DCP/NRC0990
NSD-NRC-97-5274
Docket No.: 52-003

SUBJECT: RESPONSES TO COMMENTS ON THE AP600 STANDARD SAFETY ANALYSIS
REPORT (SSAR) CHAPTER 15 ACCIDENT ANALYSES

**ATTACHMENT 1
TO WESTINGHOUSE LETTER DCP/NRC0990
Comment Responses**

Figure 64. Affected loop steam generator normalized heat transfer versus normalized liquid mass for Tests S-FS-6, S-FS-11, and S-FS-7.

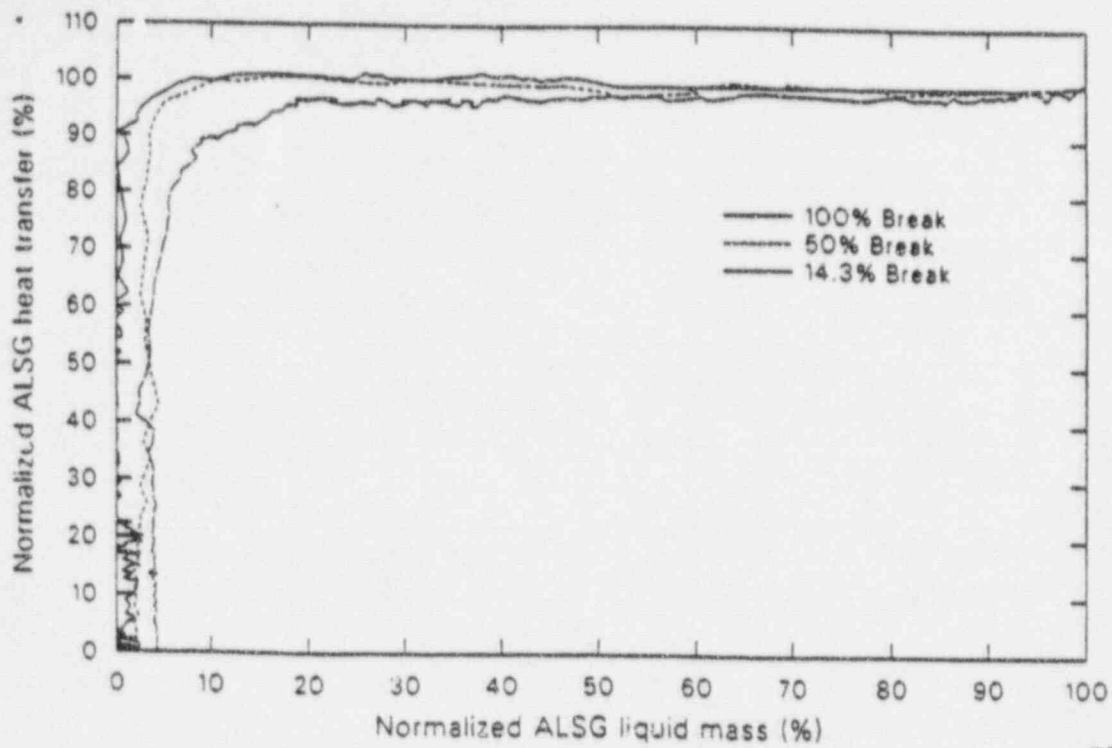
The Semiscale test data for feedwater line breaks (as discussed in Section 4.3.3.2 of NUREG/CR-4945, dated July 1987) showed that the steam generator heat transfer capacity remains unchanged until the steam generator liquid inventory is nearly depleted. This is followed by a rapid reduction to 0 percent heat transfer with little further reduction in the steam generator water inventory. In light of these test data, provide a discussion of the steam generator heat transfer model used in the feedwater line break analysis and verify the model is conservative as it is compared with the Semiscale test data. If the model is found to be nonconservative, reanalyze the feedwater line break event by using the model that is supported by the test data including Semiscale test data. With a heat transfer model consistent with the Semiscale test data, perform a sensitivity study of break sizes to identify the worst break size and provide the results for the staff to review.

"The normalized heat transfer versus normalized liquid mass (normalized to initial values) for the three tests are shown in Figure 64. For the 100% and 50% break test (S-FS-6 and S-FS-11), the heat transfer remained at 100% until the liquid mass reached about 5 to 10%. The heat transfer then reduced to about 90% over the next 5% reduction in liquid mass followed by a rapid reduction to 0% heat transfer. For the 14.3% break test (S-FS-7), the heat transfer remained at 100% until liquid mass reached about 20% followed by a rapid reduction to 0% heat transfer starting at 8% liquid inventory. Although a slight break size dependency is indicated by these results, the basic trend is very similar: the heat transfer remains at nearly 100% until the liquid inventory is nearly depleted. This is followed by a rapid reduction to 0% heat transfer with little reduction in mass. The Combustion Engineering (CE) FSAR Appendix 15B²²¹ assumes for a feed line break that there is 100% heat transfer until the liquid inventory is depleted, followed by a step change reduction in the heat transfer to 0%, which is nonconservative based on Semiscale scaled results."

Attached is Figure 64 from NUREG/CR-4945 which shows the Semiscale steam generator heat transfer as a function of steam generator liquid mass.
